SYDNEY NORTH PLANNING PANEL

ADDENDUM REPORT

Panel Reference	PPSSNH-140						
DA Number	DA113/2020						
LGA	Lane Cove						
Proposed Development	Mixed-use development including a 143-bed residential care facility and commercial premises including a medical centre premises, and basement parking.						
Street Address	4-18 Northwood Road & 274-274A Longueville Road, Lane Cove						
Applicant/Owner	Applicant: City Plan (Contact: Elyse Kenny) Owner: Pathways Property Group Pty Ltd						
Date of DA lodgement	28/08/2020						
Number of Submissions	256						
Recommendation	REFUSAL						
Regional Development Criteria (Schedule 7 of the SEPP (State and Regional Development) 2011	Development that has a capital investment value of more than \$30 million (CIV \$40,837,440.00).						
List of all relevant s4.15(1)(a) matters	<ul style="list-style-type: none"> • List all of the relevant environmental planning instruments: s4.15(1)(a)(i) <ul style="list-style-type: none"> - SEPP (Housing for Seniors or People with a disability) 2004 - SEPP 55 – Remediation of Land; - SEPP (Infrastructure) 2007; - SEPP (Building Sustainability Index) 2004; - SEPP (Vegetation in non-rural areas) 2017; - SEPP No. 19

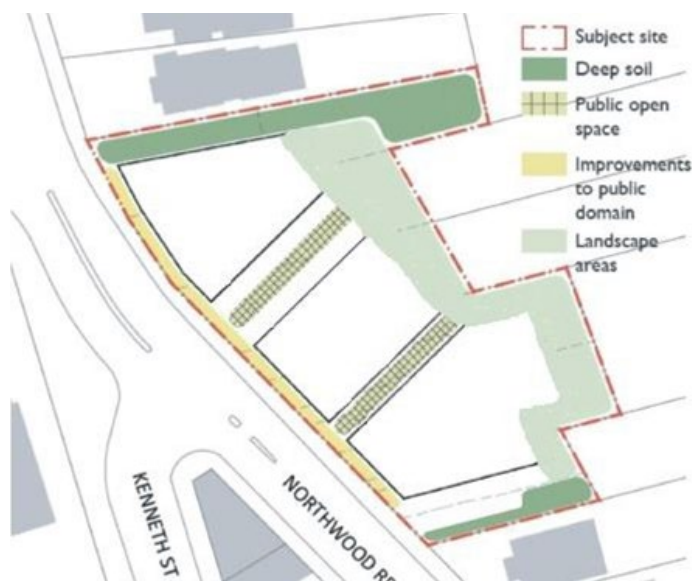
- The proposed rear setback has not been amended.
- 10m bushland buffer still not indicated on all boundary lines that it occurs. Built form still encroaching on bushland buffer areas. Refer DCP Part D extract below:

Figure 1. Pedestrian view – Kenneth Street looking east (Source: Drawing DA503, Revision DA2, MDP Architects)

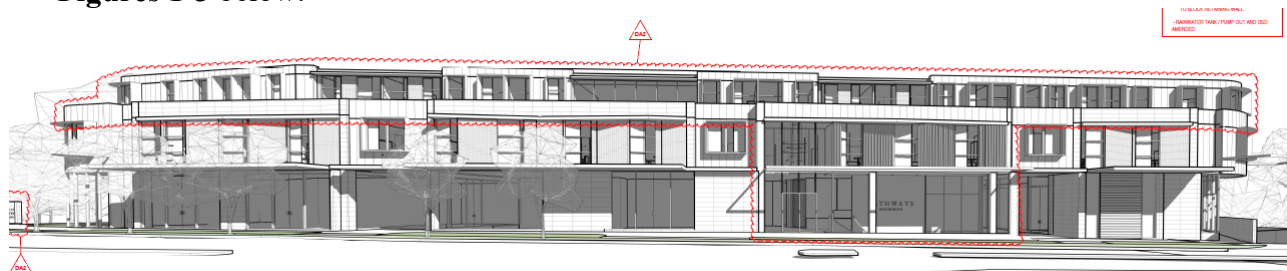
The amended plans have increased the upper-level setback to 6m (street boundary) however, it is recommended that the 8m setback is adhered to for the following reasons:

- The amended proposal would still read as 3-storeys, as depicted in the pedestrian views at **Figures 1-3** below:

Figure 8. Non-compliant rear setback of 2.75m (southern side) and 3m (northern side) for the curtilage to the south-eastern section of the development.

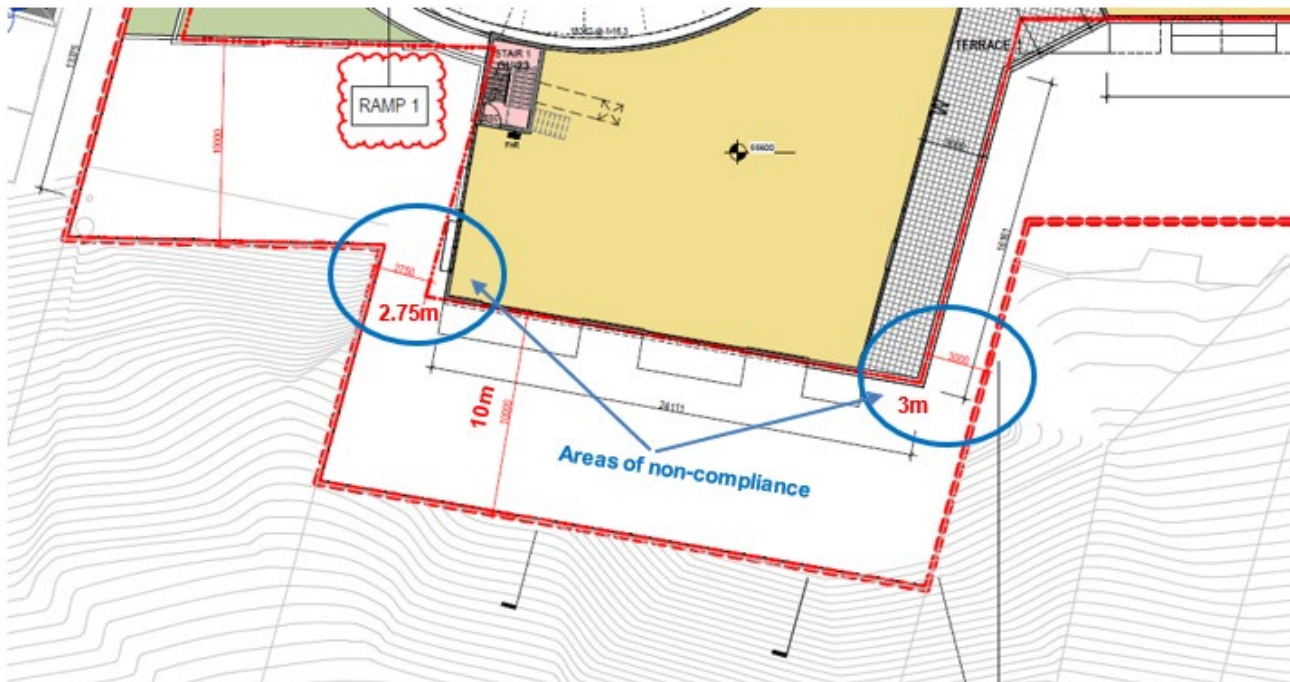
The curtilage to the proposed south-eastern section of the proposed building at the rear comprised of a 2.75m setback on the southern side and 3m setback on the northern side would not comply with the 10m buffer zone requirement, which seeks to ensure that the adjoining bushland is maintained and protected (**Figure 8**).

- 10m bushland buffer to adjacent E2 zoned land under *Part H Bushland Protection* of Lane Cove DCP 2010 (Part H prevails to the extent of any inconsistency); and
- 10m rear setback requirement under Clause 10 of Part D – Locality 2 of Lane Cove DCP 2010.

Figure 9. 10m bushland buffer/rear setback requirement indicated by line in 'red'.

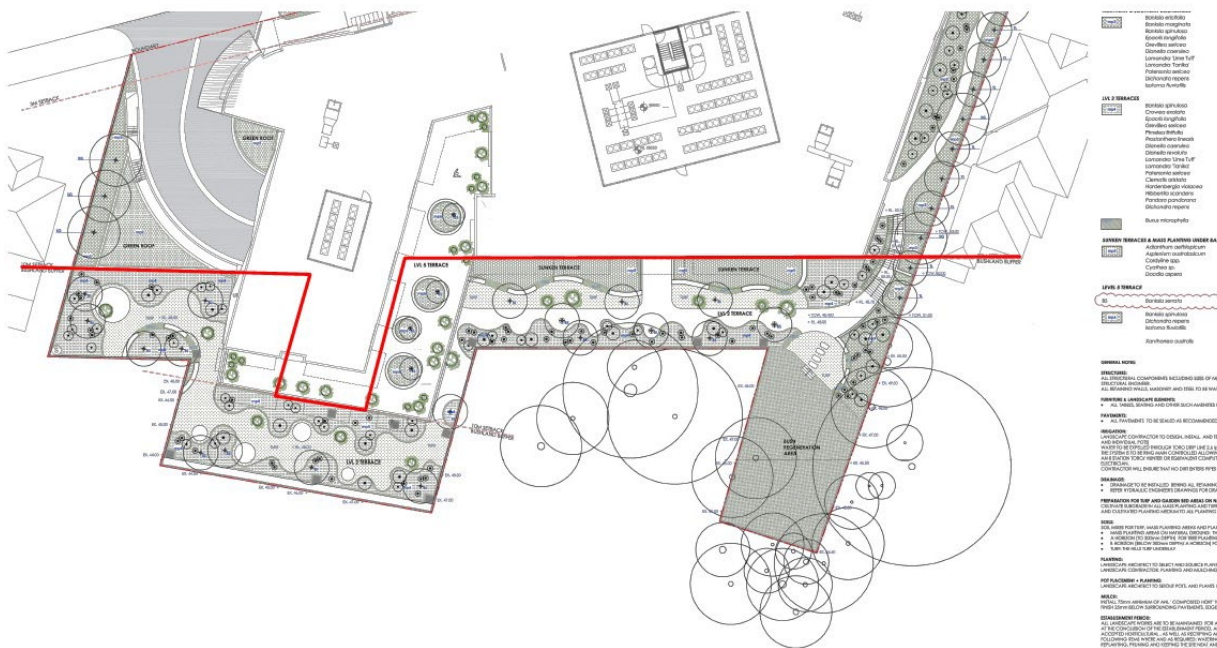
The 10m bushland buffer is shown in 'red' at **Figure 9**. This was provided to the Applicant during our meeting on 31/03/2021 to clarify Council's position on the portion of the development that would be required to be deleted (**Figure 10**) to reduce the impact on the adjoining bushland and achieve compliance.
